ADDENDUM NO. 04

FIRE STATION NO. 5, HIGHLAND PARK THE CHATTANOOGA FIRE DEPARTMENT 2009 VANCE AVENUE CHATTANOOGA, TENNESSEE 37404

CITY OF CHATTANOOGA CONTRACT NO. F-14-002-201 ARCHITECT'S JOB NO. 6750

December 7, 2016

CS1.1.01

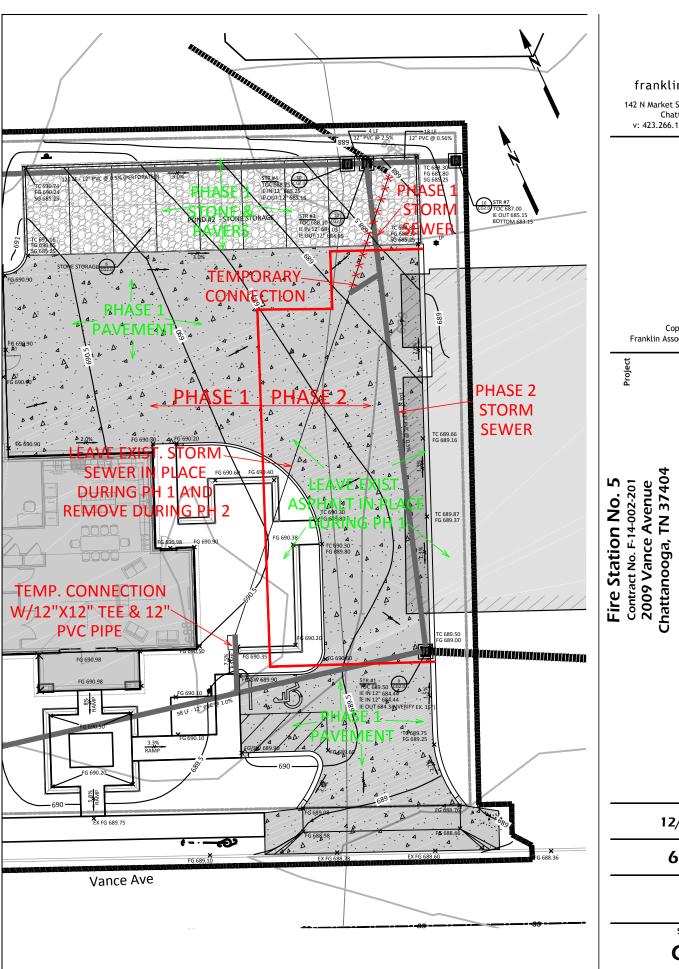
Item No. 01: Refer to Sheets CG1.1, and reference to notes CS1.0 and CS1.1. Notes on CS1.0 and CS1.1 state that "The Contractor shall phase construction as required". The contractor shall provide temporary connection to the storm sewer system until the existing building is removed, and then complete the storm system. A temporary Certificate of Occupancy will be allowed by the City for the time of building demolition and completion of the storm and site work in this area.

See attached sketch, CS1.1.01 Storm Water Phasing Plan Option, for an option for storm water phasing around the existing fire station by temporary connection of the proposed system to the existing system. The Contractor shall submit a Storm Water Phasing Plan for approval prior to construction of the same. The Contractor shall modify any erosion control as required based on his Submittal.
